MORONGO BAND OF MISSION INDIANS
BANNING, CALIFORNIA

ADDENDUM NO. 4

EQUIPPING DOMESTIC WELL 7A & 8

DWG. NO. E-14

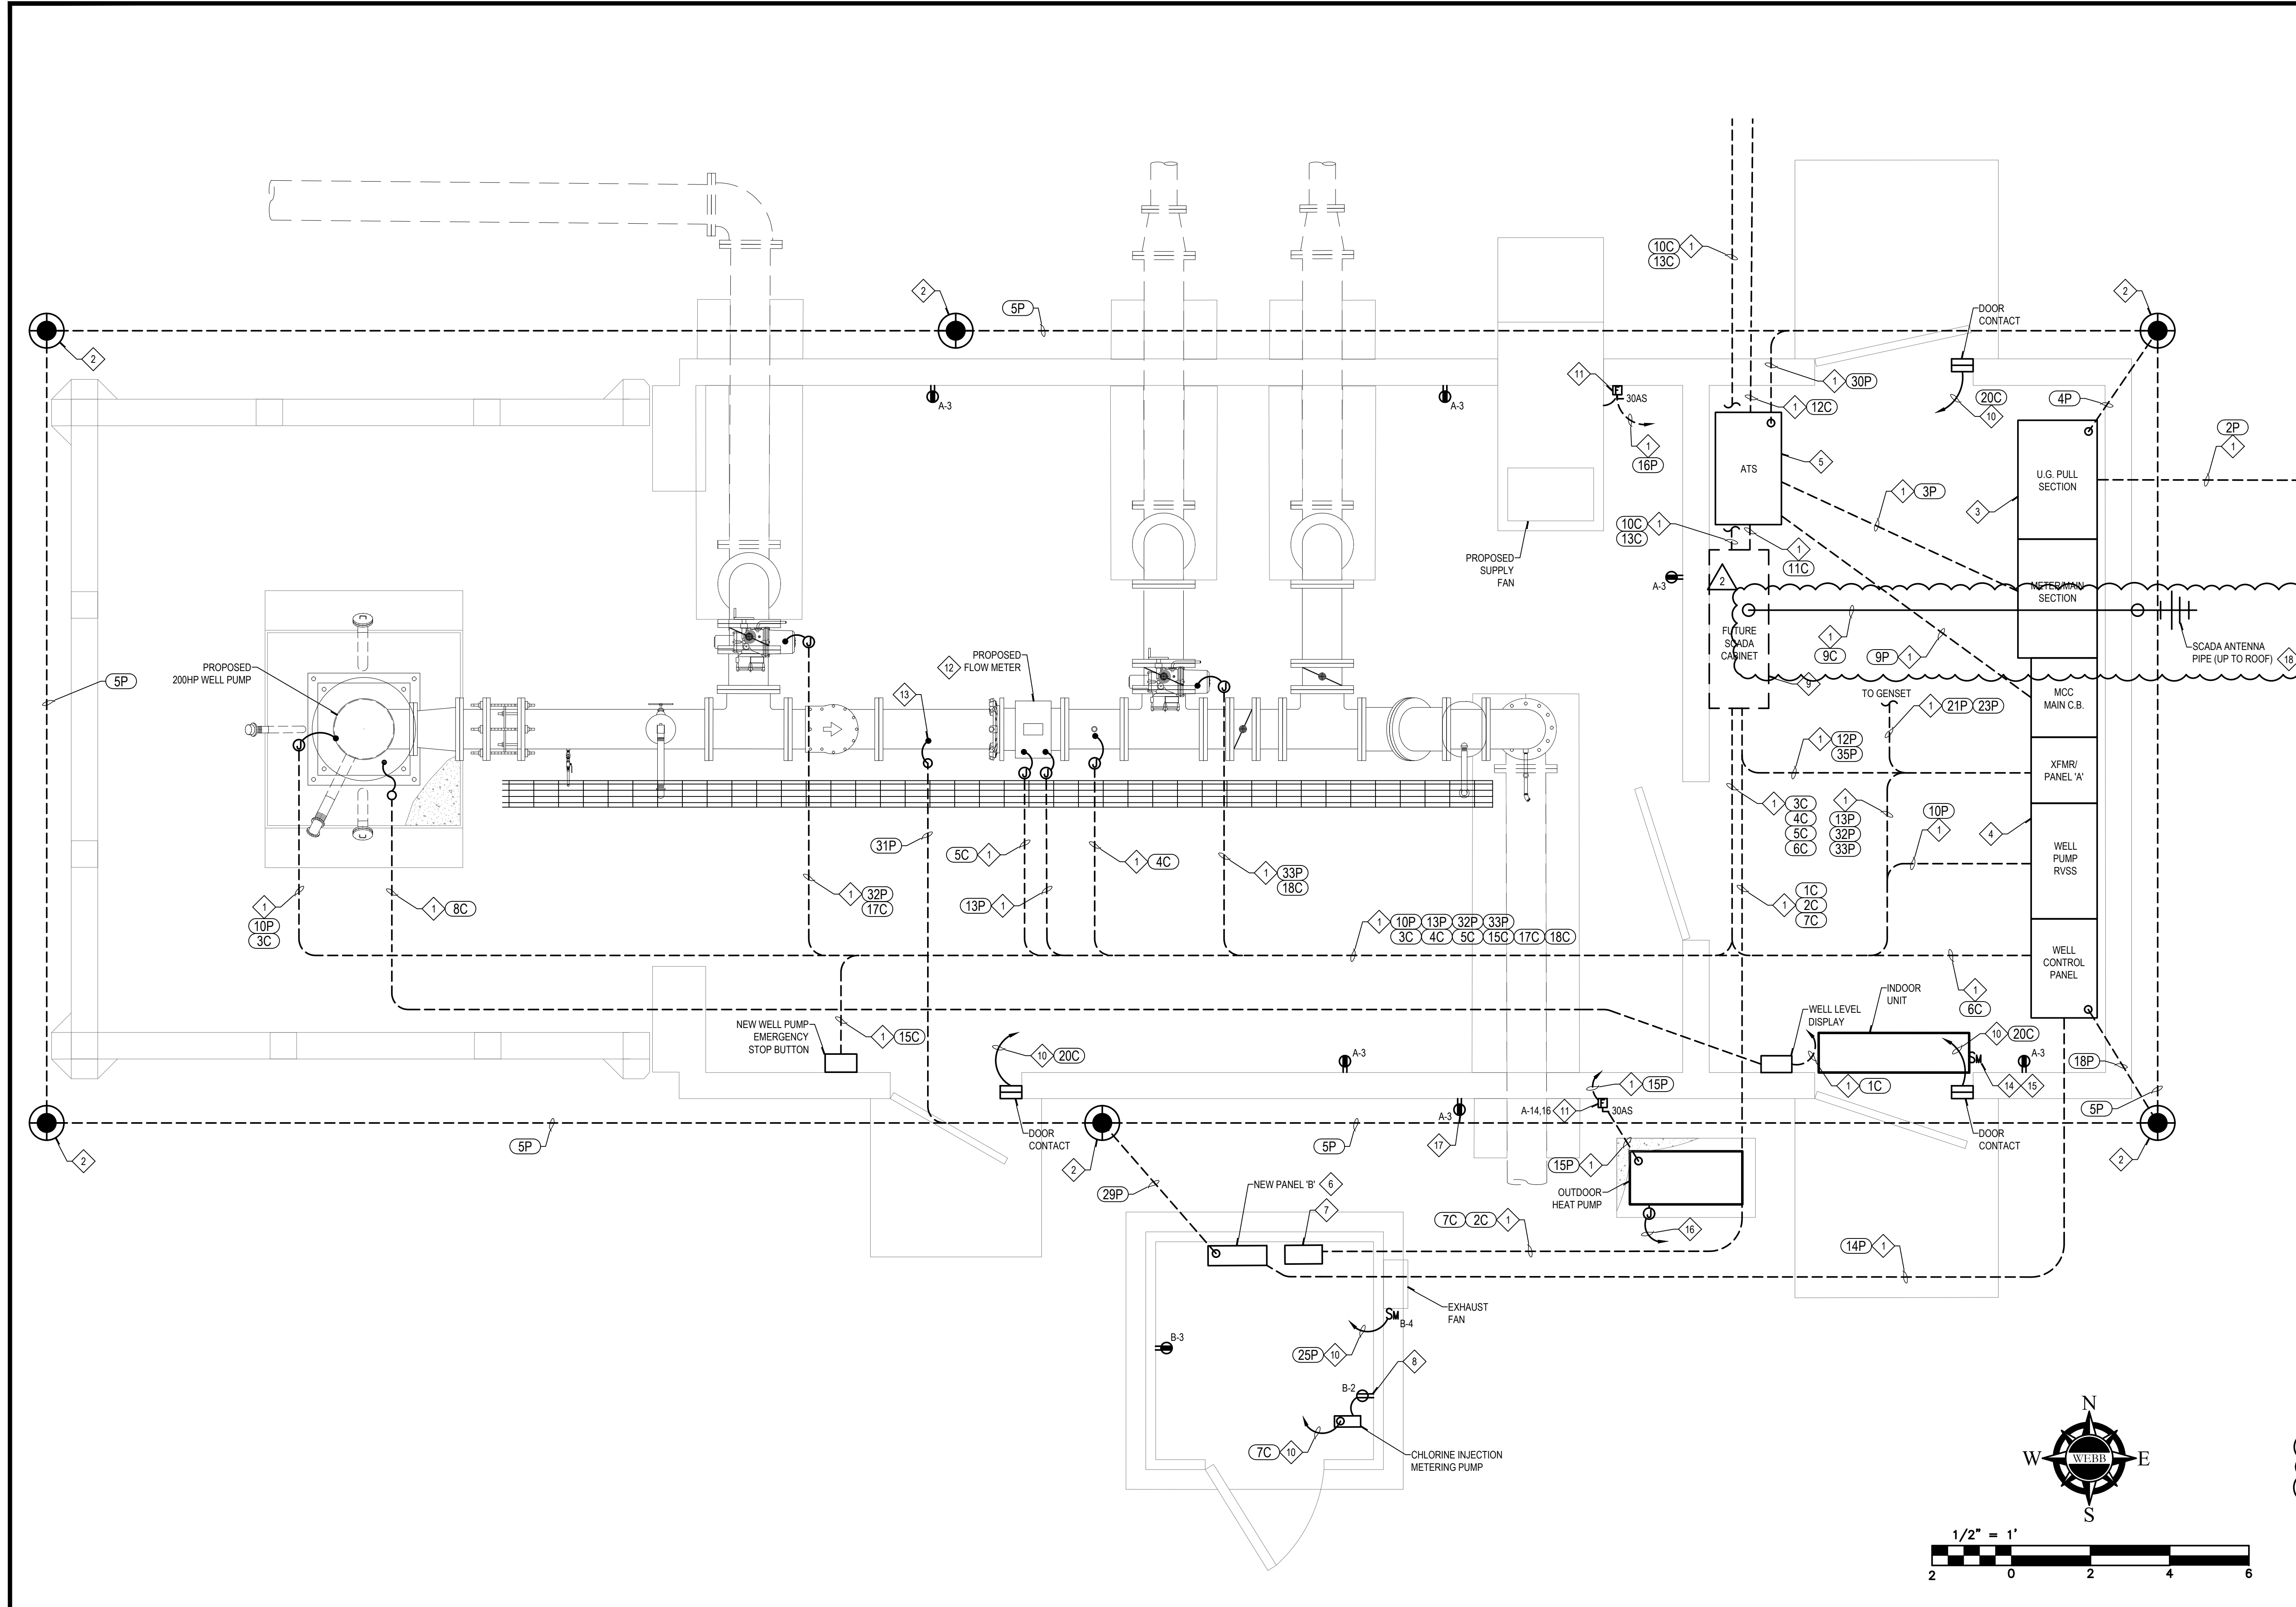
Drawing No. E-14, E-15, and E-20 in **Attachment 2**, showing the revisions to the SCADA antenna.

5. What is Flowmeter size? When in check scaling in E-14, it seems size is 6". But I do not think it is correct. Please clarify it is 12" per sheet M-1

9. Addendum #3 added a detail where the new Antenna will be mounted to the side of the building, however, the attached specification is calling for a new 56' Antenna mast as indicated on drawings. I see nothing on the drawings for the new mast.

Answer: Flowmeter size is 12" as indicated on Dwg. No. M-1. The flow meter size appears to match sheet M-1 as 12". The sheet scale is 1/2" = 1'-0" on sheet E-14.

Answer: Antenna will be mounted to the side of the building as indicated on revised Drawing Nos. E-14 and E-15 in **Attachment 2**.

SHEET 38 OF 38

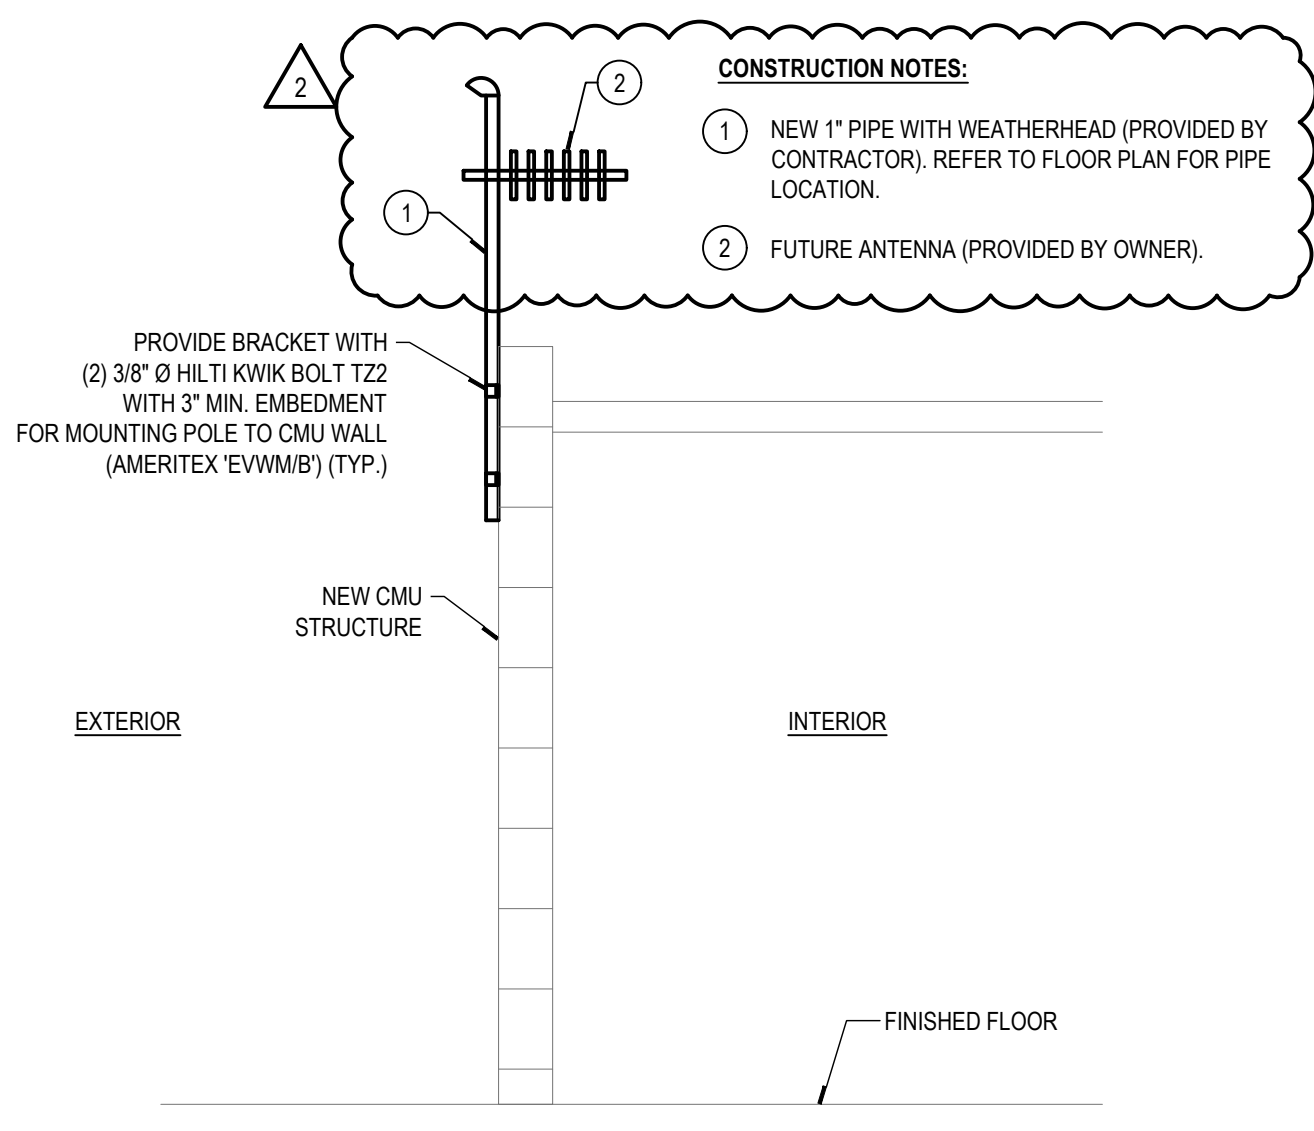
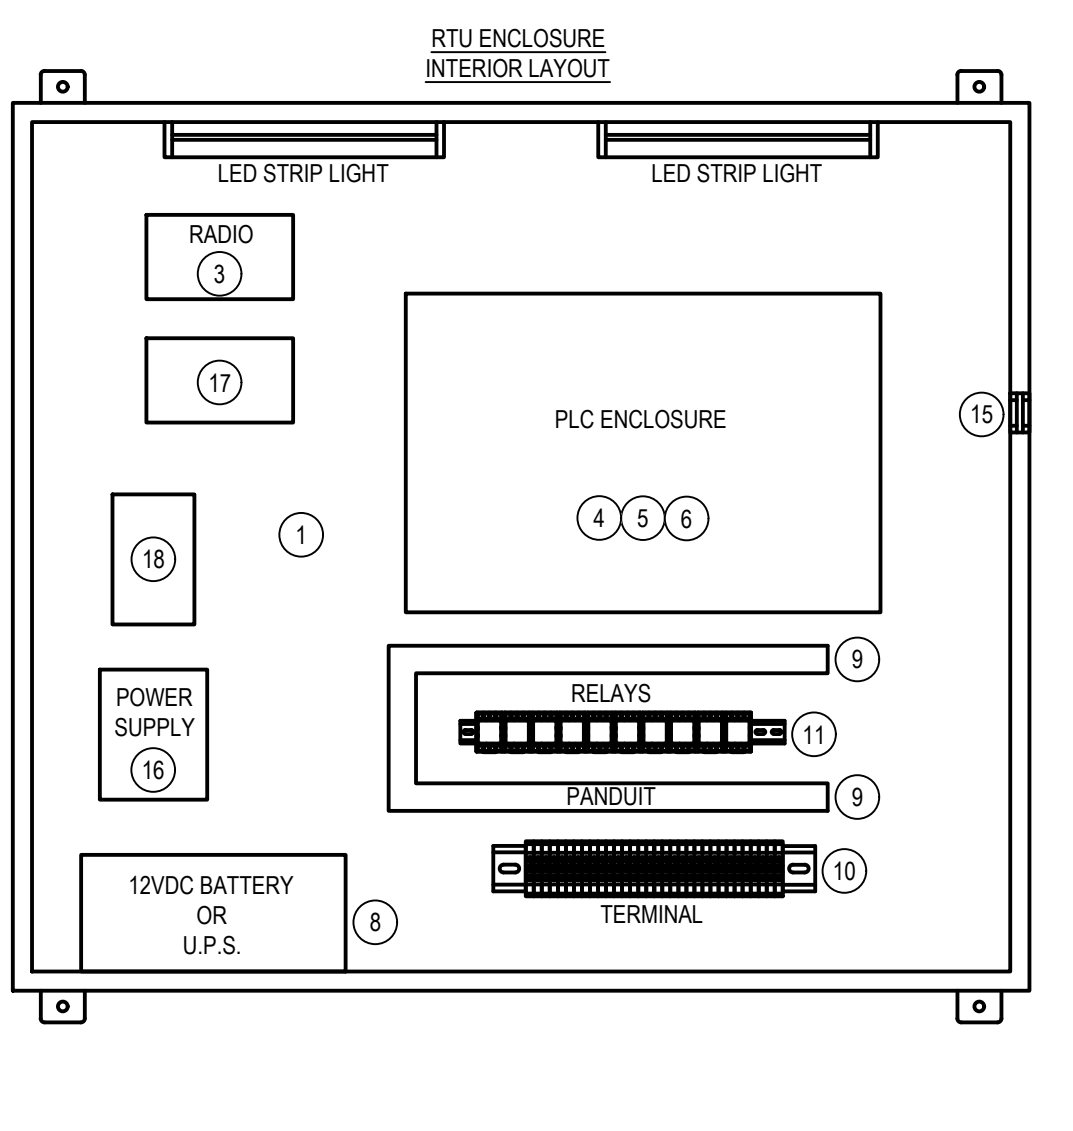
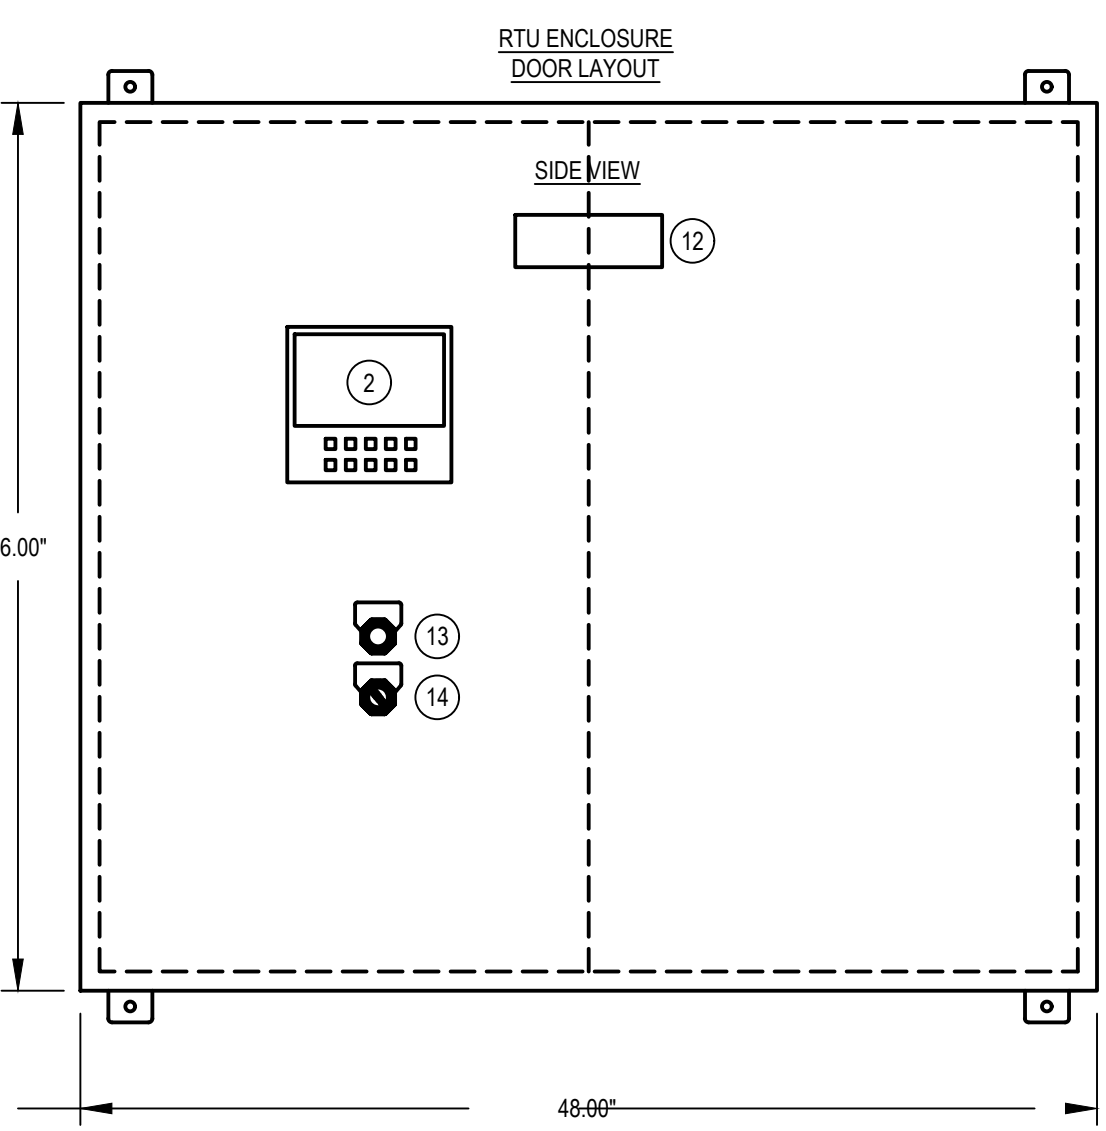
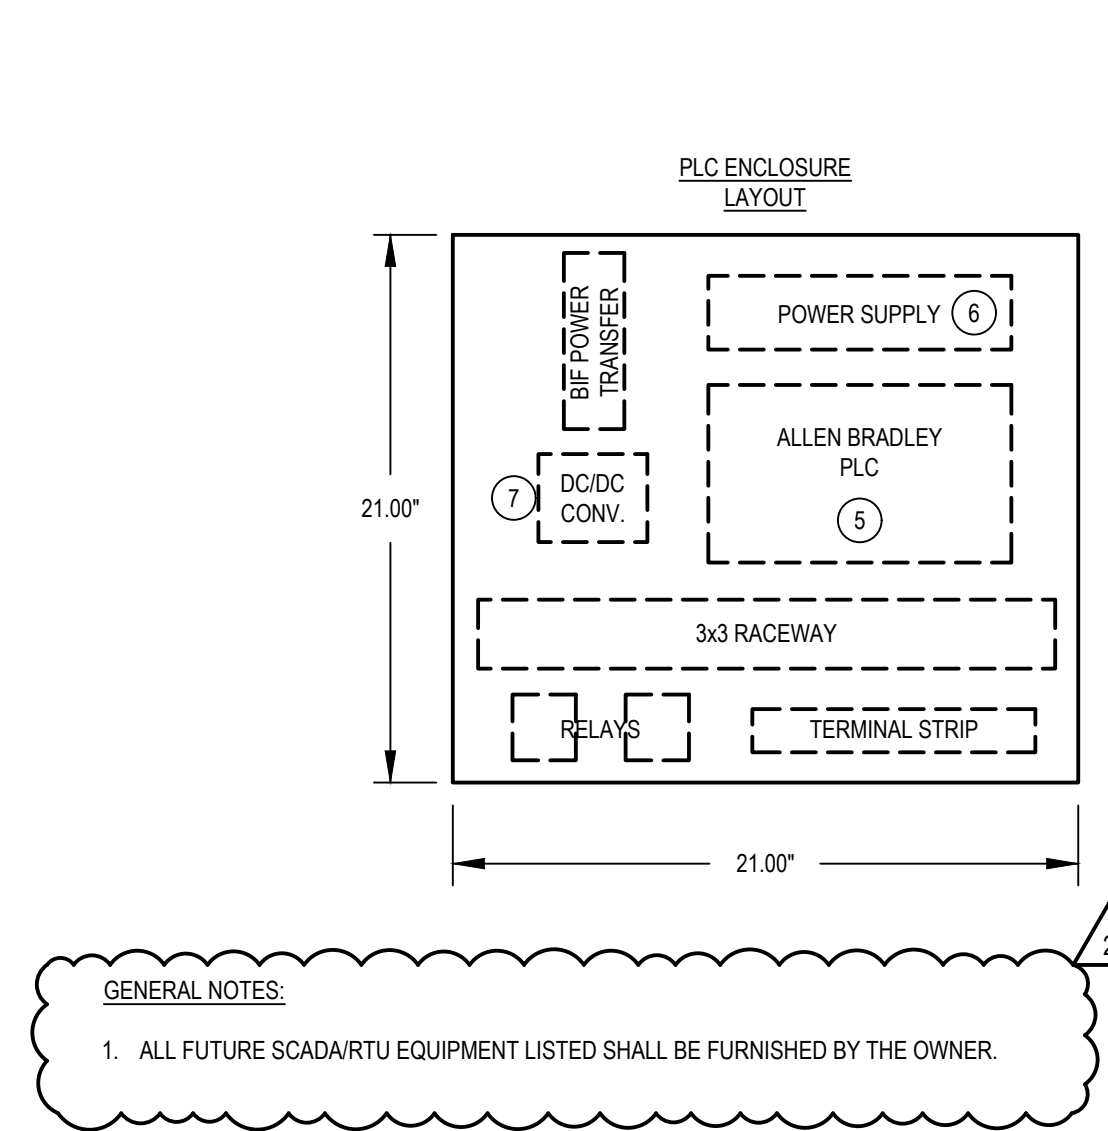
7. In spec 17010-2, there is BOM for RTU Control panel, in E-20, there is other BOM for RTU. But in mentioned Future SCADA/RTU. Please clarify, they are with us.

8. The RTU BOM, has different Radio model. Which one is more priority?

Answer: The BOM for RTU Control Panel shall follow the spec section 17010-2. Detail on sheet E-20 shall be updated to refer back to spec section. See **Attachment 1** for revised Section 17010.

Answer: The BOM for RTU Control Panel shall follow the spec section 17010-2. Detail on sheet E-20 shall be updated to refer back to spec section. See **Attachment 1** for revised Section 17010.
